10 CFR 50.4, Written Communications  
UFTR Operating License R-56, Docket 50-83

Subject: **UFTR Responses to Request for Additional Information (TAC NO. ME1586)**

By letter dated July 18, 2016, the NRC requested additional information regarding proposed UFTR license renewal Technical Specifications (ML15336A796). By letter dated July 25, 2016, the NRC requested additional information regarding the technical details provided for UFTR license renewal (ML15336A005). A total of 114 RAIs were requested with a scope that includes requests for new analyses and updated analyses. Both sets of RAIs requested that changes be made to the proposed license renewal Technical Specifications.

**Table 1) Bundle Powers (+/-3%) for BOL and EOL at Limiting Critical Position**

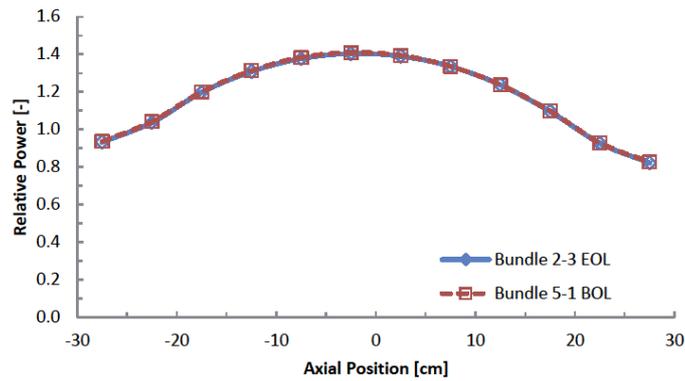
1. UFTR SAR, Chapter 4, "Reactor Description," describes the general purpose Monte Carlo N-Particle code (MCNP6) model used to determine the SLs for the UFTR. The NRC staff reviewed the analysis, and is not clear regarding the use of any additional uncertainties, peaking factors, or power shapes, to represent the power gradients which result in a conservative peak fuel temperature and minimum departure from nucleate boiling ratio (DNBR).

The table below shows the bundle powers at BOL and EOL for the UFTR. As the figure below shows, the effect on axial peaking due to burnup is minimal.

**Figure 6-1 UFTR Organizational Chart**

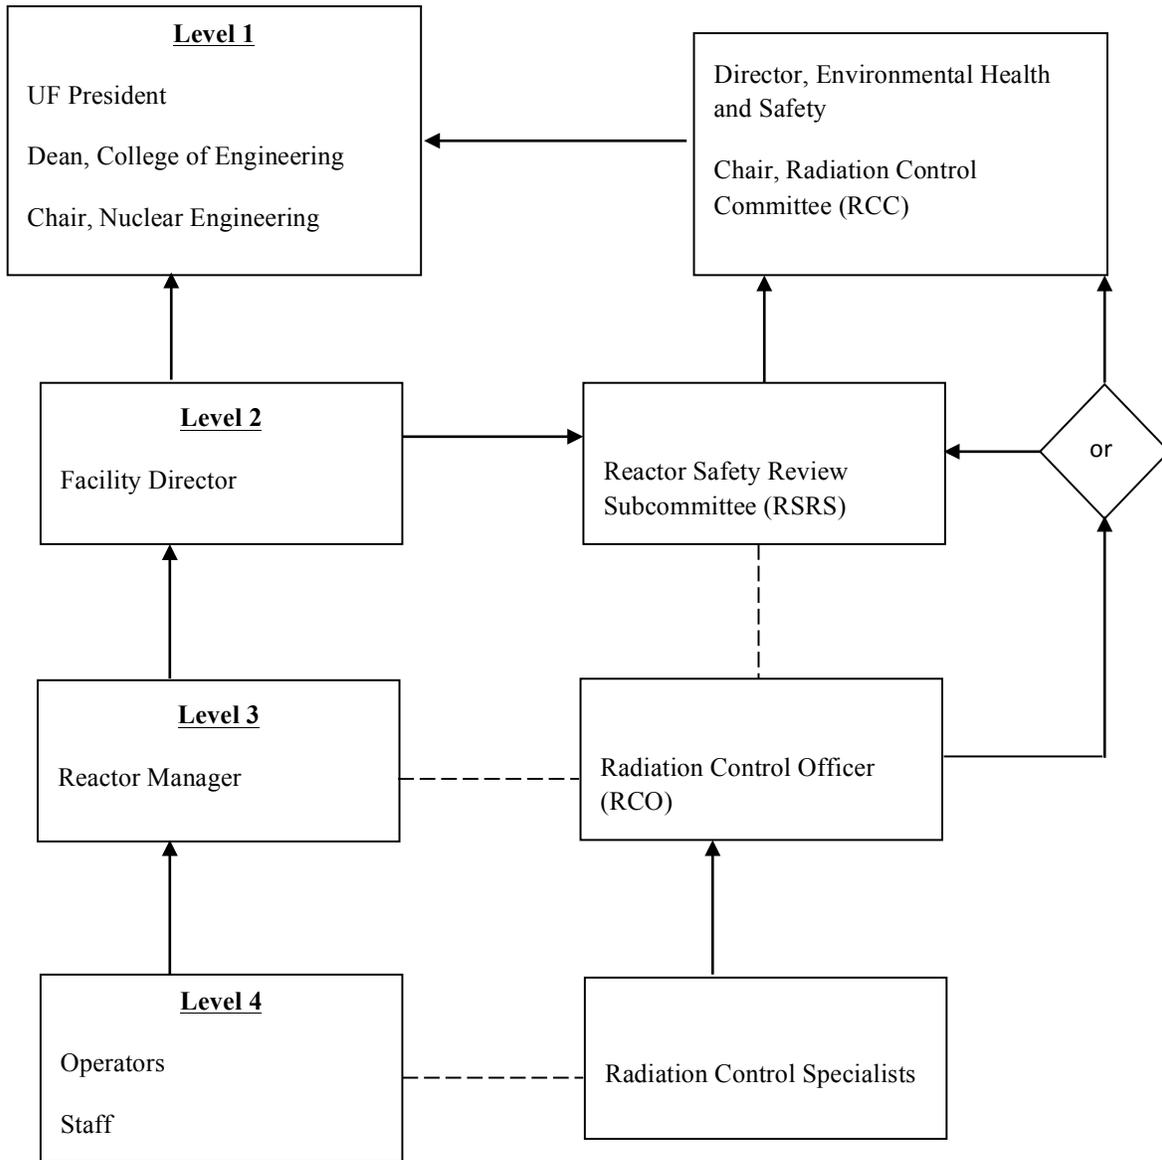
- a. *UFTR TS 6.1.1, "Structure," references Figure 6-1, UFTR Organizational Chart. The proposed figure identifies the responsible Level 1 individuals as the "VP. Business Affairs," and the "Dean, College of Engineering." The current UFTR organizational chart lists the Level 1 (Figure 6.1) as the "UF President, Dean, College of Engineering, Chairman, Nuclear & Radiological Engineering Department." Modify Figure 6-1 to be consistent with the prior approved Level 1 individuals or provide a detailed explanation of how the Level 1 individuals identified in proposed Figure 6-1 will be responsible for the reactor facility's licenses, charter, and site administration.*

Figure 6-1 has been revised.
